Sandy Creek Townhomes (Replat)

**Request for Plat Waiver
from Street Design Standards and Sidewalk Requirement**

Planning Commission Meeting
September 5, 2018

Sidewalk Requirement

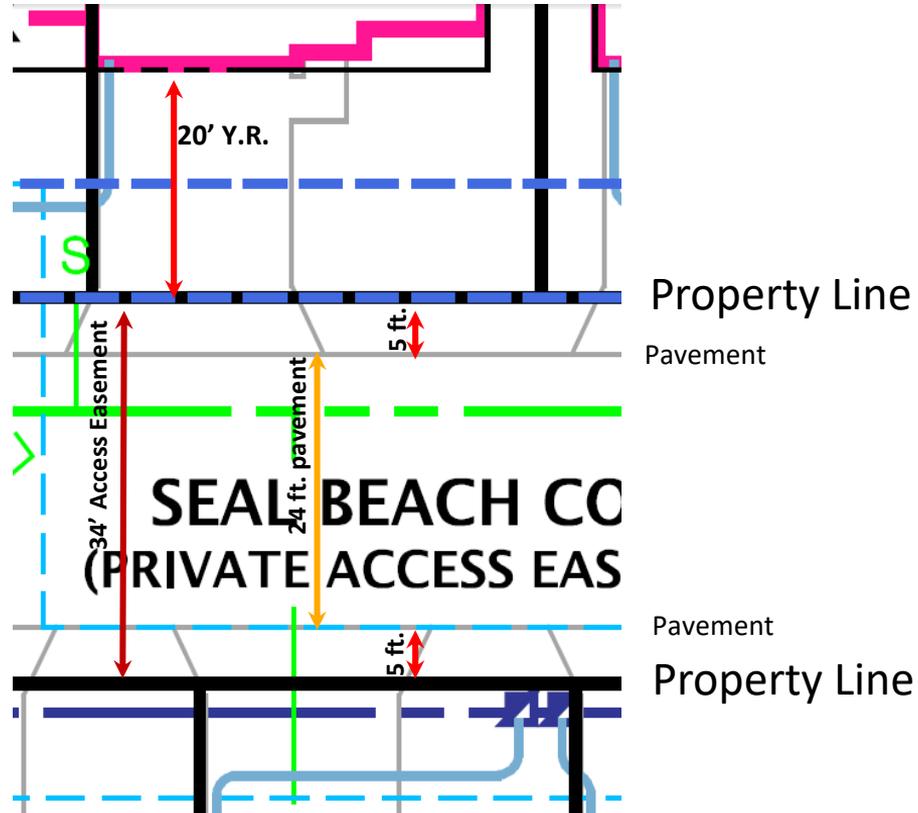
34-foot Private Access Easement, for private street

34-foot private access
Easement allows space
for:
24' pavement
(Two 12' lanes)
Two 5' sidewalks

Section View

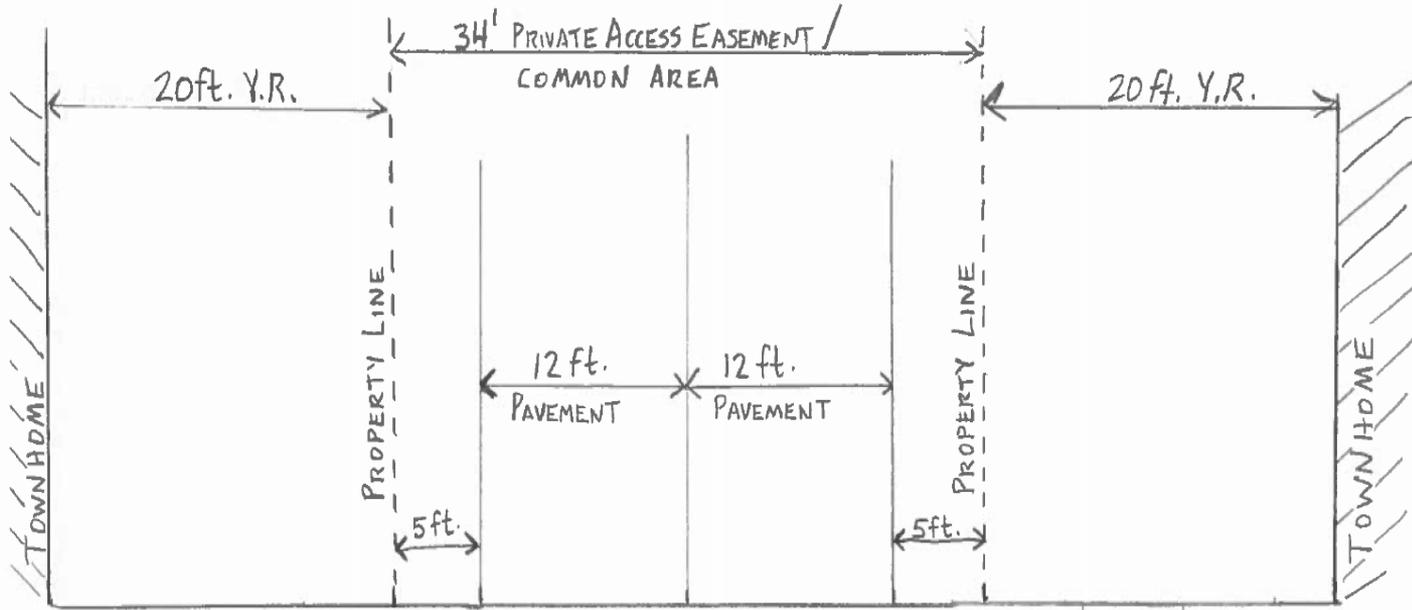
- Applicant states:
 - Concrete pavement will have 30-year life
 - Designed to withstand weight of fire truck and solid waste truck
 - Subdivision is gated; reduced traffic; infrequent fire truck traffic
 - Inverted roadway instead of curb and gutter; stormwater directed to the center of roadway, to inlet

Staff recommends approval of the request for waiver from the street design standards.
